**ADDENDUM NO. 1 TO PROJECT NO. 44920**

**HVAC WORK AND ELECTRICAL WORK  
PROVIDE CENTRAL AIR CONDITIONING  
ADMINISTRATION BUILDING NO. 24  
ALBION CORRECTIONAL FACILITY  
3595 STATE SCHOOL ROAD  
ALBION, NY**

December 9, 2015

M-701

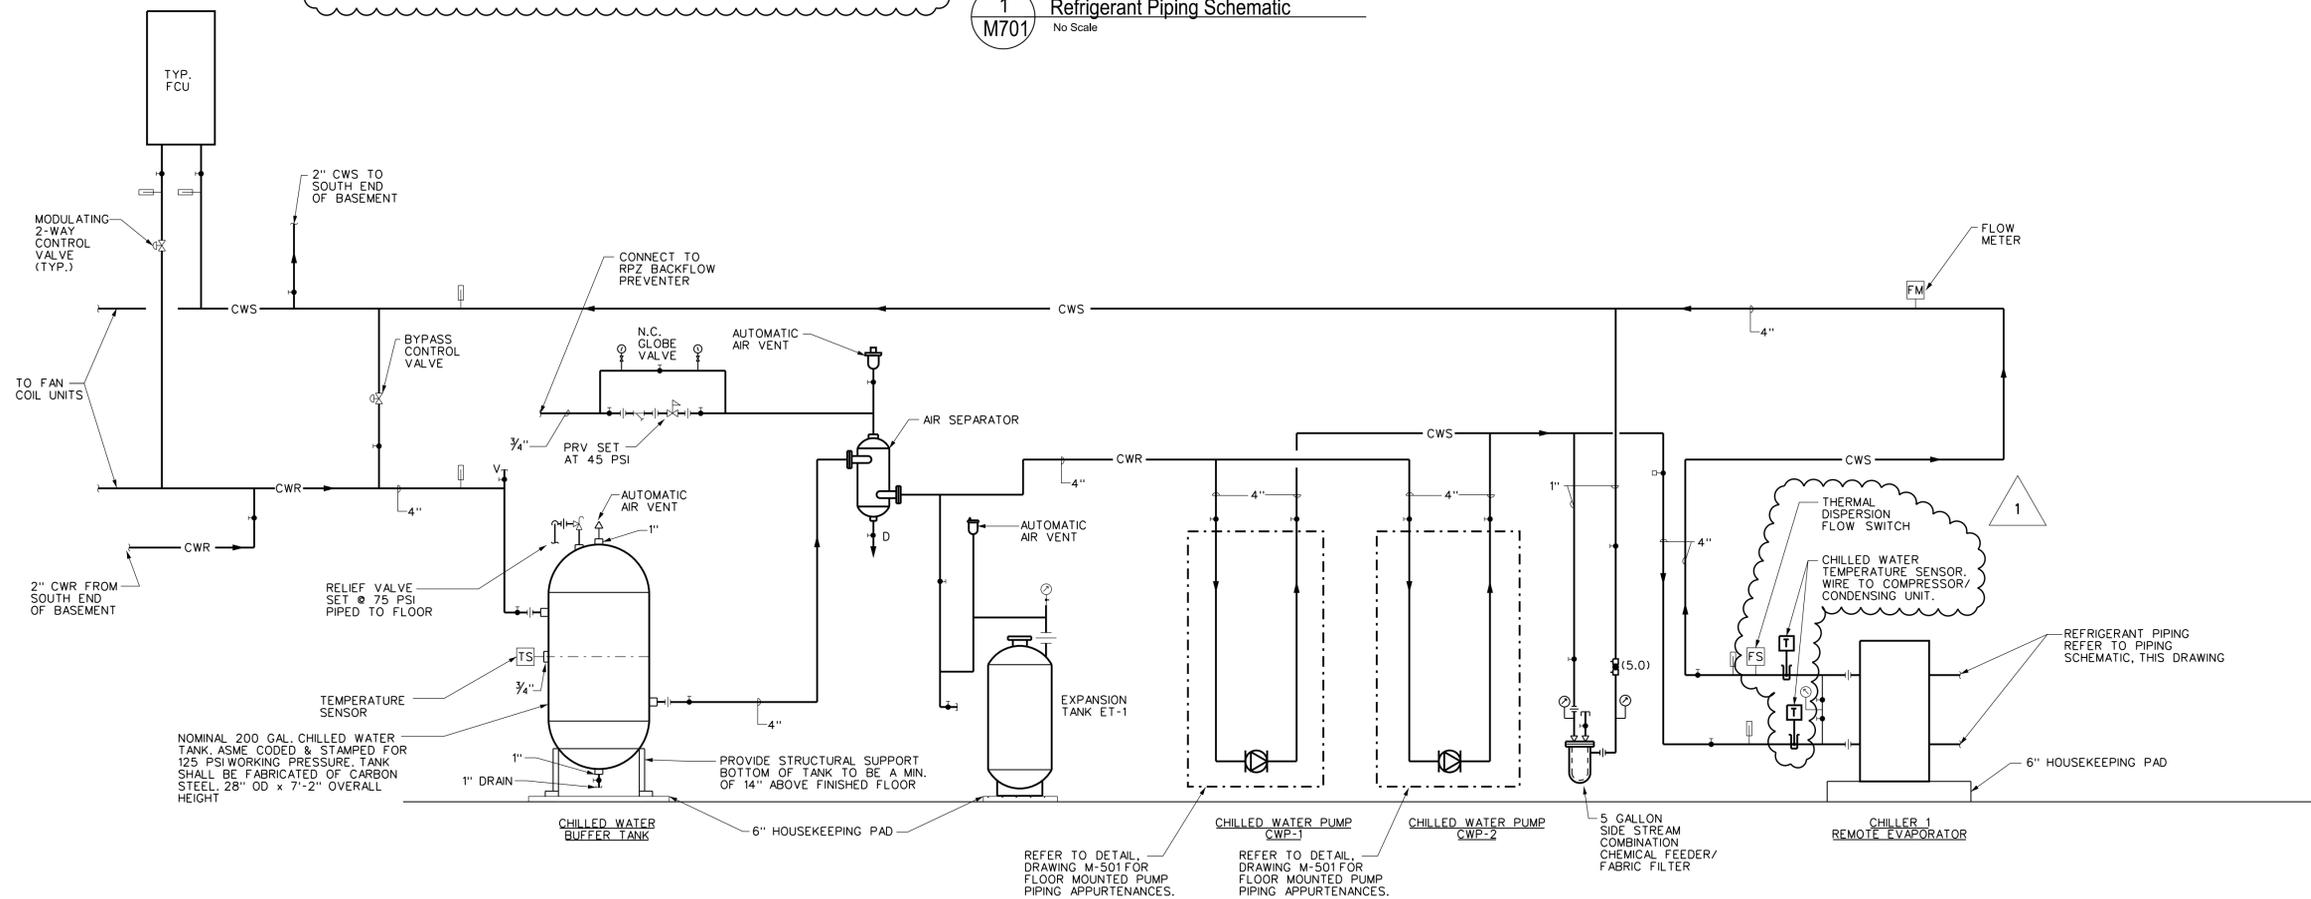
7. Drawing No. M-601, PACKAGED AIR COOLED SCROLL CHILLER SCHEDULE:
  - a. Sound Pressure Column: Change "67 dBA" to read "61 dBA".
  - b. Sound Power Column: Change "94 dBA" to read "88 dBA".
8. Revised Drawings:
  - a. Drawing No. M-701 noted "REVISED DRAWING 12/04/15" accompanies and supersedes the same numbered originally issued Drawing.
